Talavera Floodplain Delineation Study Technical Review

Noah's Ark Group Study
Las Cruces, New Mexico
September 17, 2008

Hydrology: Inflow Points

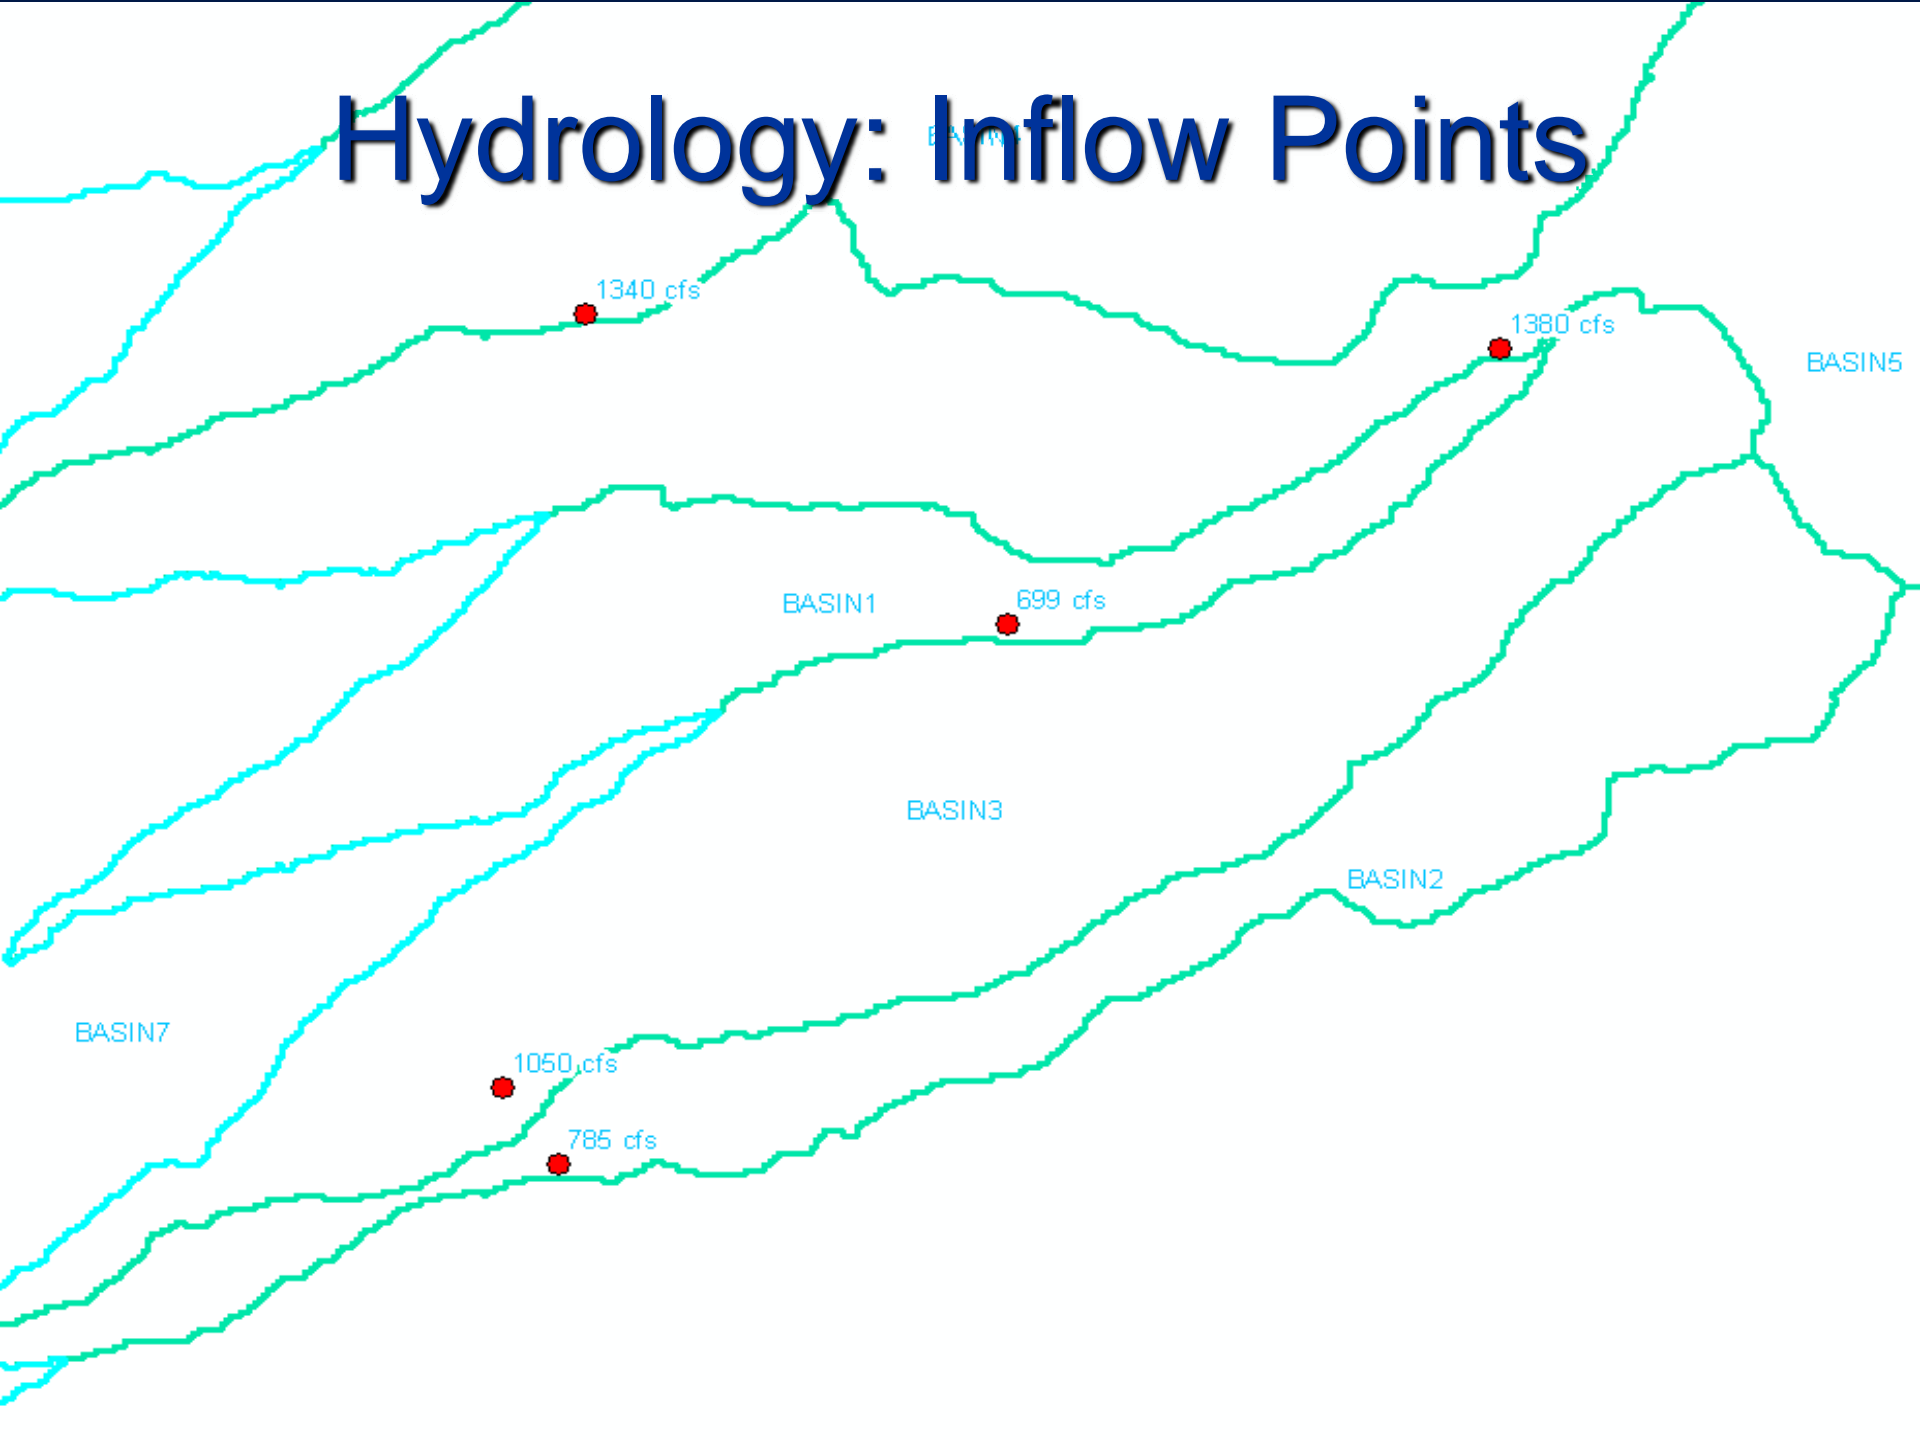
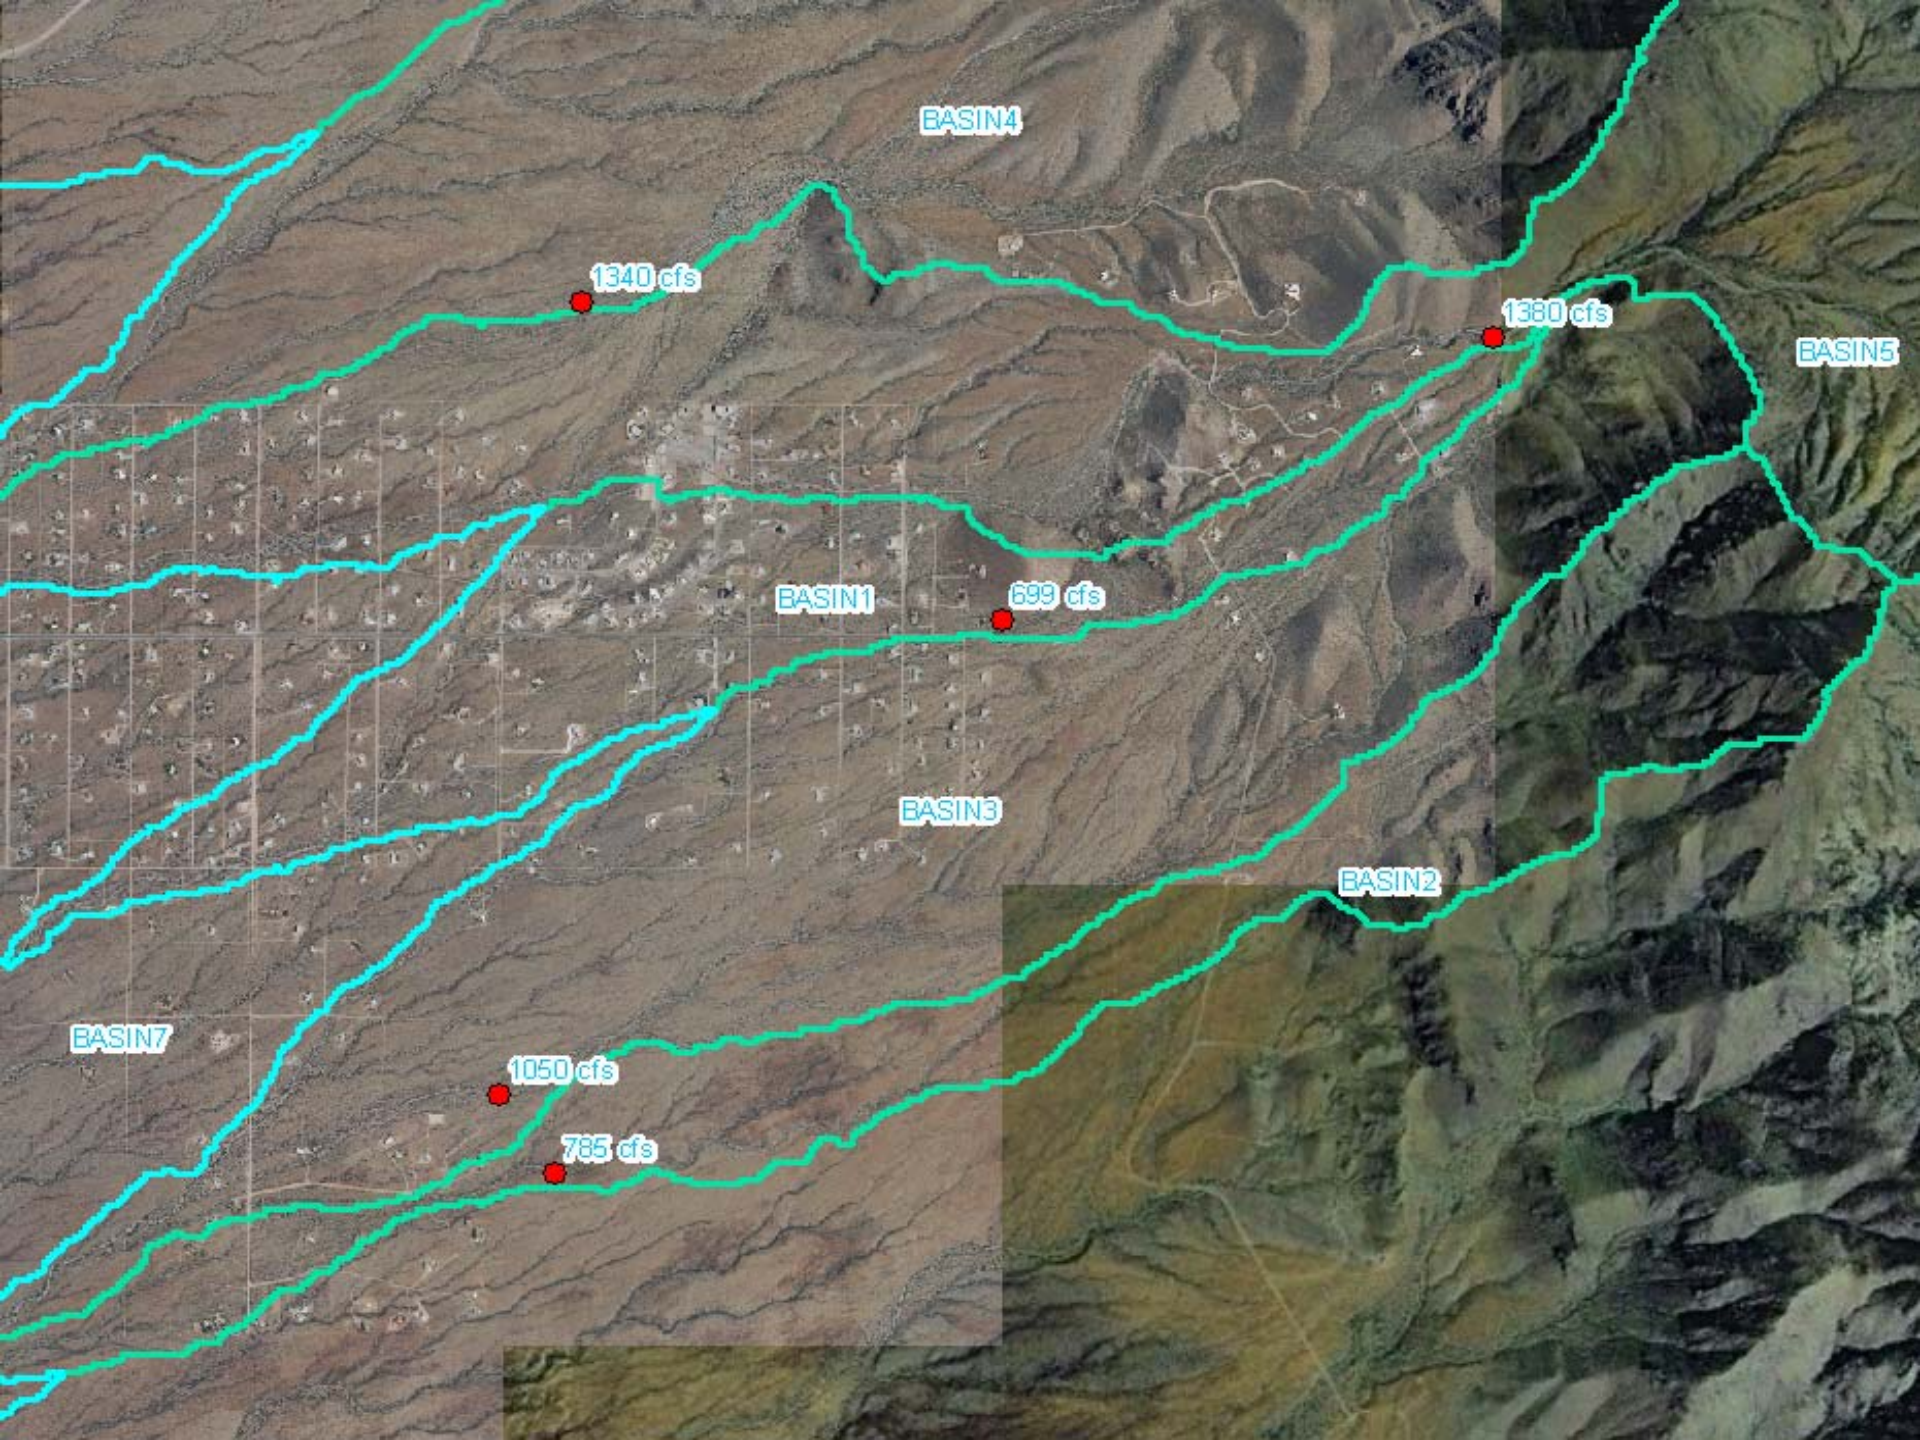
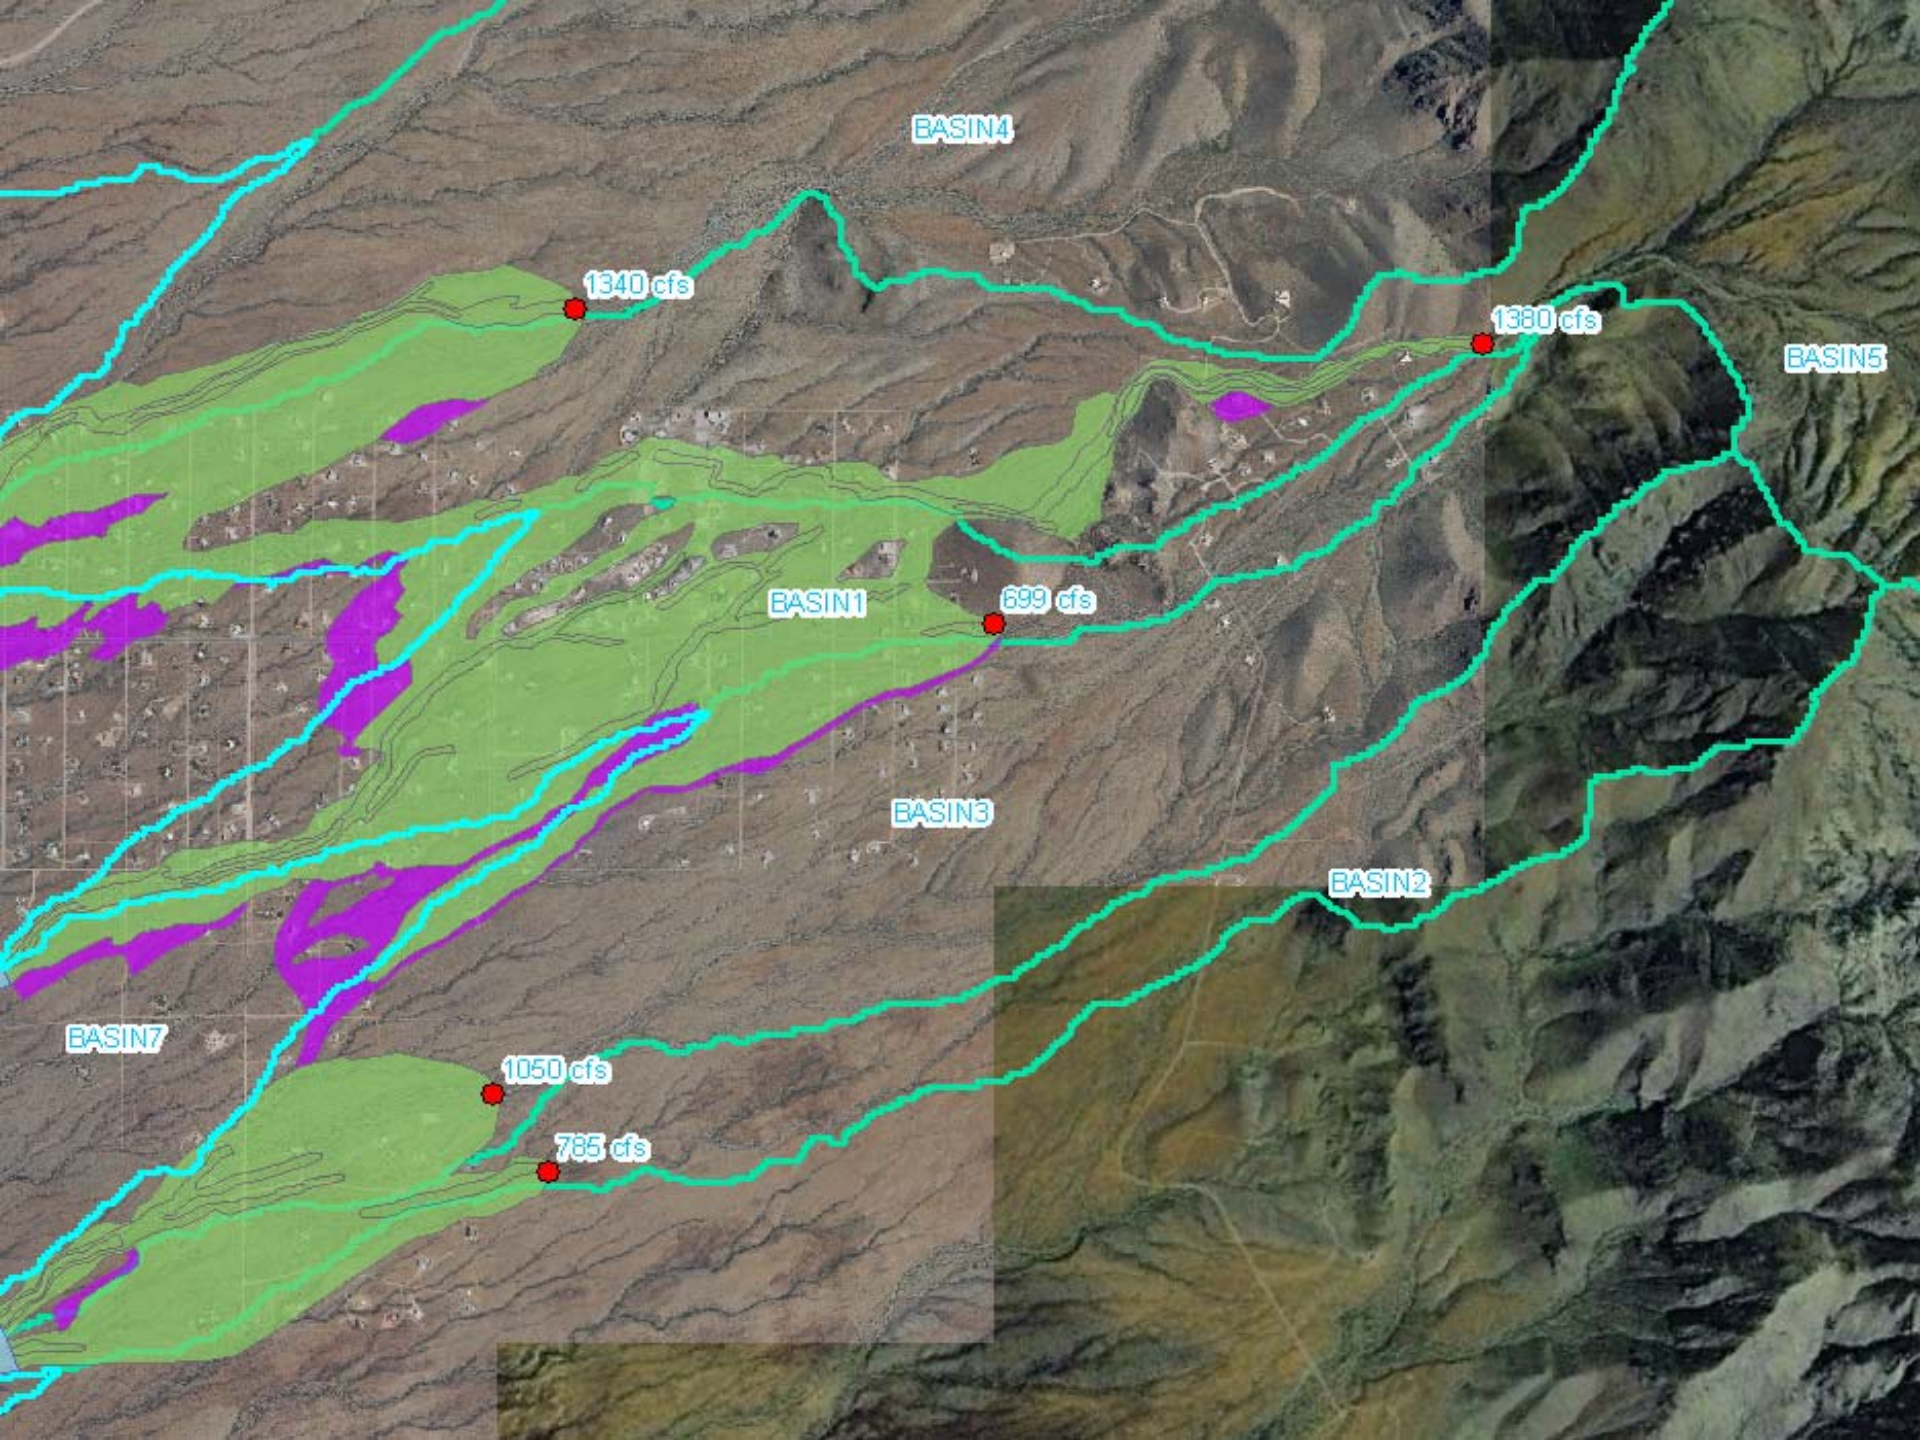
- Subbasin Delineation
 - Boundaries
 - Shape
 - Size
- Hydrograph
 - Regression Equation => Peak Only
 - Hydrograph Used vs. Modeled
- Discharge Inflow Points

Hydraulics: Inflow Points

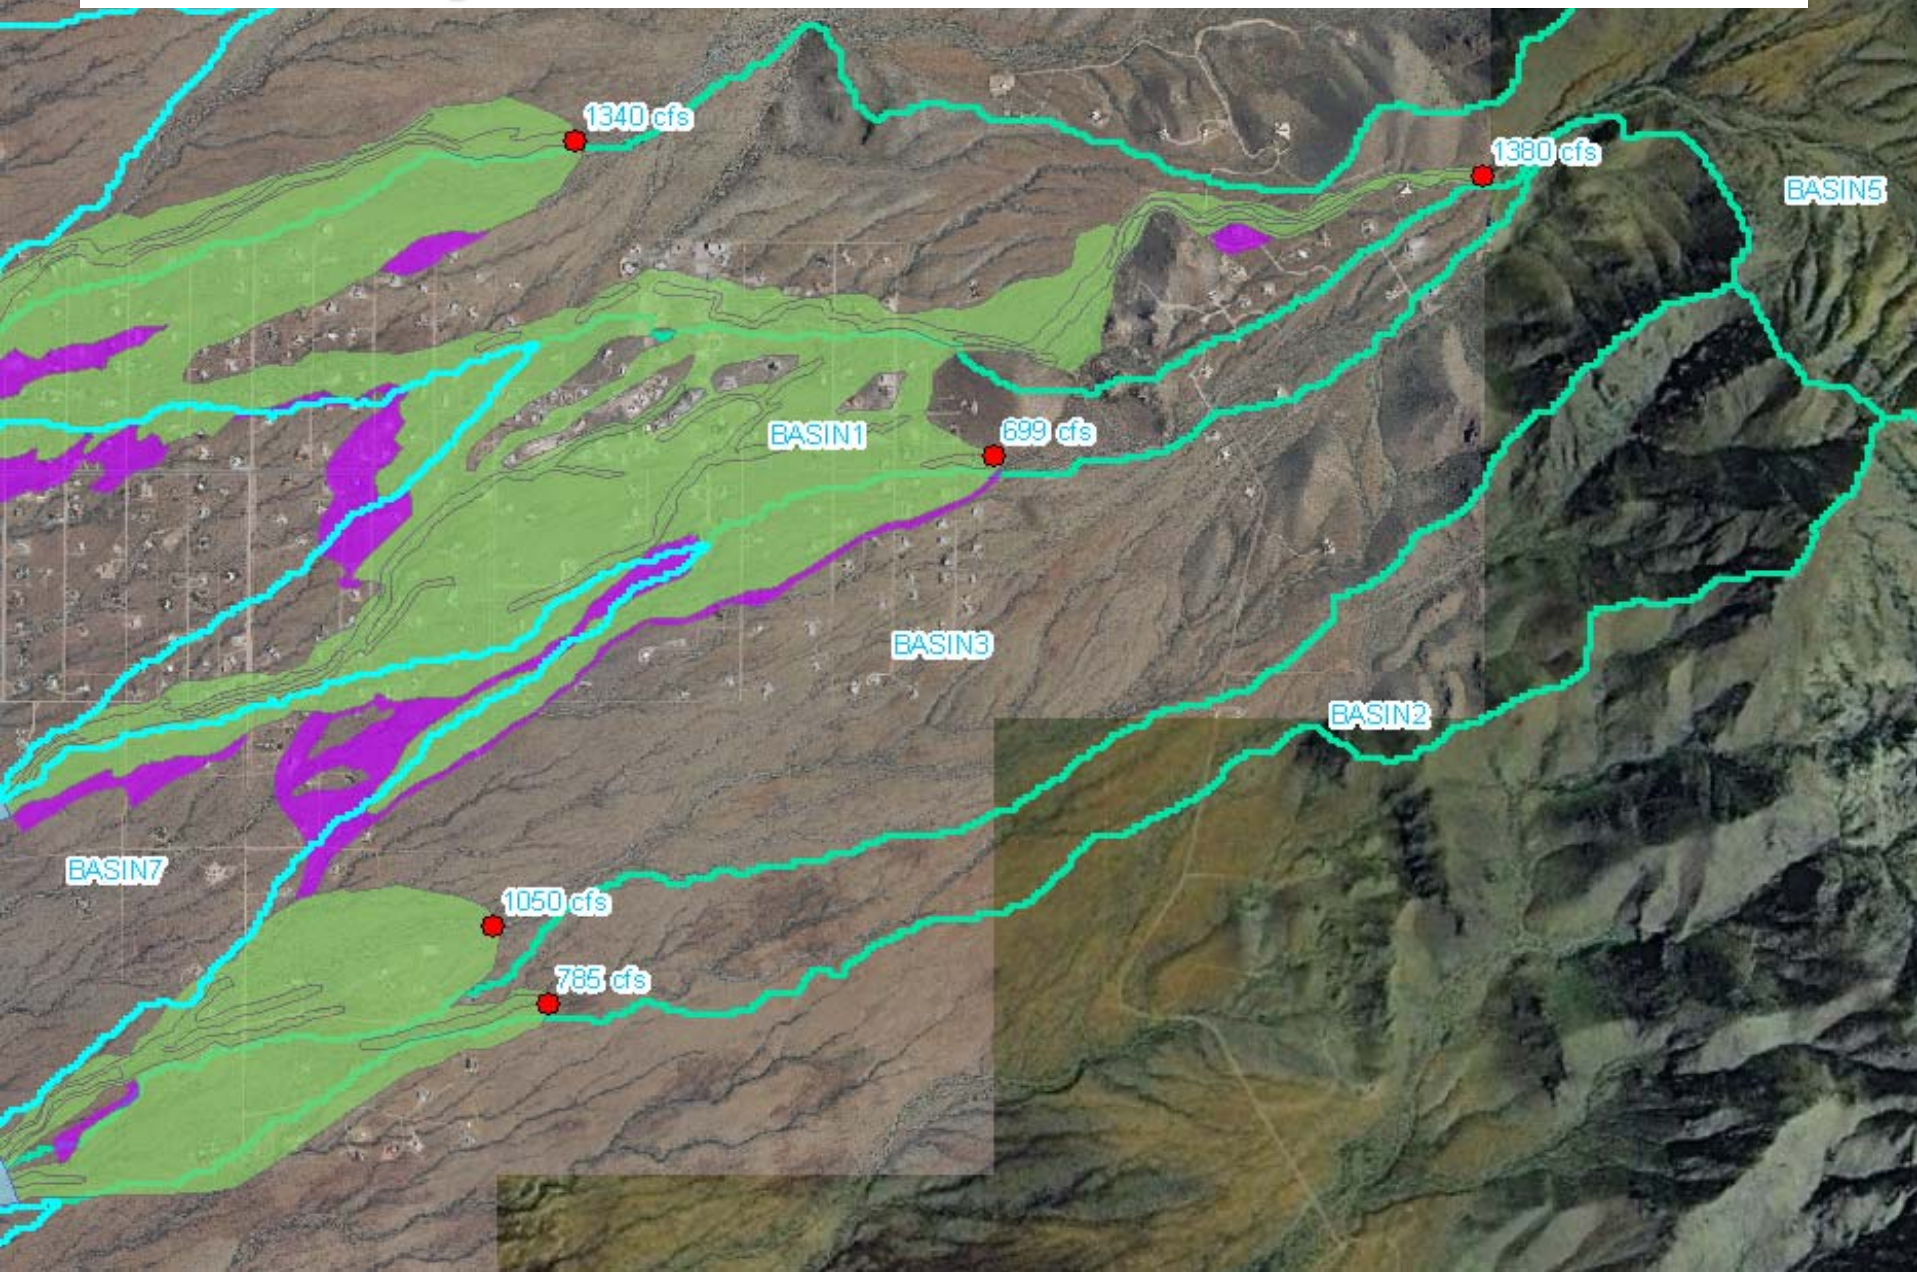
- FLO2D
 - Two-Dimensional Computer Model
 - Grid Based
 - State-of-the-Art
- Flaws in Application:
 - Hydrograph Shape
 - Discharge Inflow Points
 - Infiltration
 - Grid Size
 - Flow Channels Missed
